Greenwich Community Association Inc

Submission to Sydney North Planning Panel

88 Christie Street, St Leonards

Section 4.55(2) Modification Application

Figure 74. Proposed colonnade design to the commercial building with frontage to the Pacific Highway.

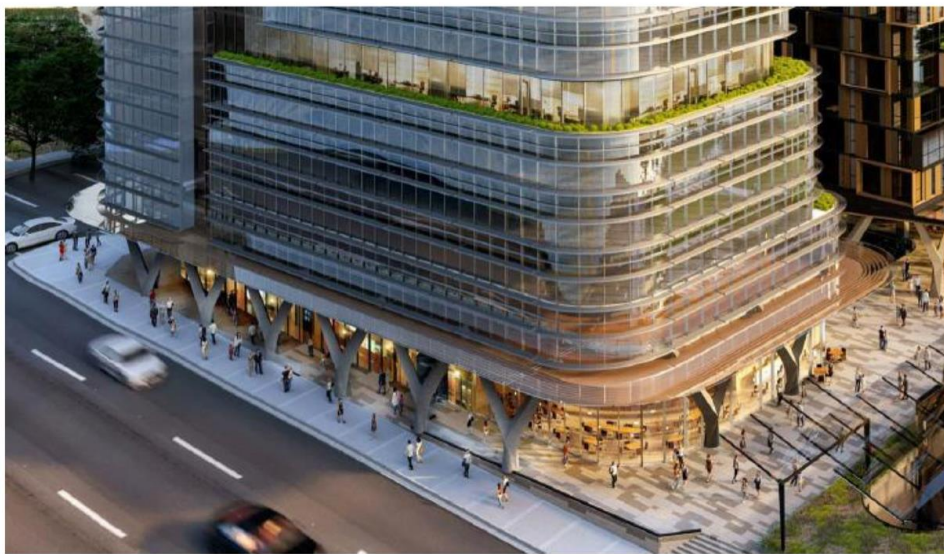
It is noted that the V shaped columns for T3 are significantly thicker and shorter than the columns proposed for T2.

This will result in a development that is not well integrated from a design perspective.

Of more concern is the impact the V shape will have in terms of pedestrian accessibility and flow and capacity for outdoor activity. The amount of usable open space will be reduced by the need to leave clearance around the lower levels of the V columns.

This is particularly relevant in relation to the columns along the Pacific Highway frontage of T3.

T3 has a minimal setback from Pacific Highway.

The proposed V shaped support columns at the base of the building will impede pedestrian movement significantly more than the original narrow vertical column of a Y shaped structure.

The applicant should be required to explore alternative support structures that enhance, not diminish, use, enjoyment and safety of the open space around T2 and T3.

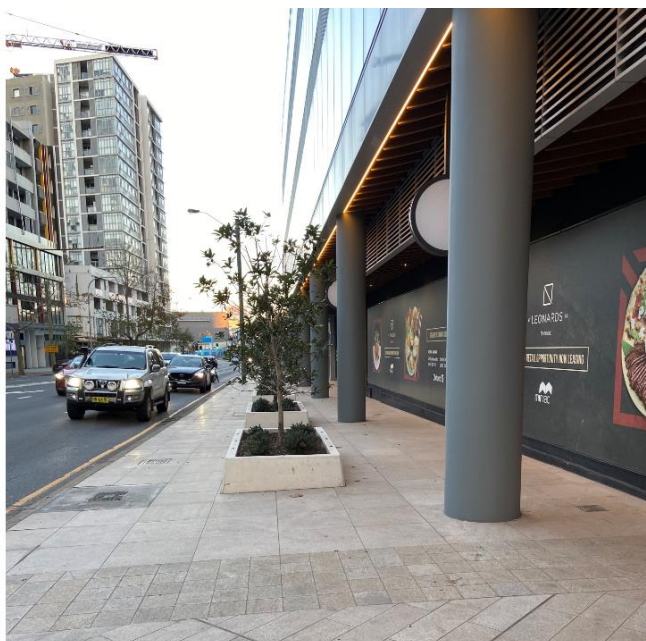
The Council report on the Section 4.55(2) modification does not address the concern expressed in Condition 18 that planter boxes will not provide trees with enough growing media to reach a size and shape that will benefit the streetscape.

There are also significant pedestrian and cyclist safety issues with placing planter boxes in the middle of footpaths.

The St Leonards Square development is a clear example of this.

Wide supporting pillars and planter boxes placed in the middle of the footpath have rendered the footpath an unsafe and diminished public space – refer photograph below taken 20/6/2020.

It is hoped that Panel members will familiarise themselves with the mistakes that have been made with the Pacific Highway frontage of the St Leonards Square development and decline approval for the planter box modification proposed for the JQZ site.

The inclusion of planter boxes on the Pacific Highway frontage of T3 should be refused.
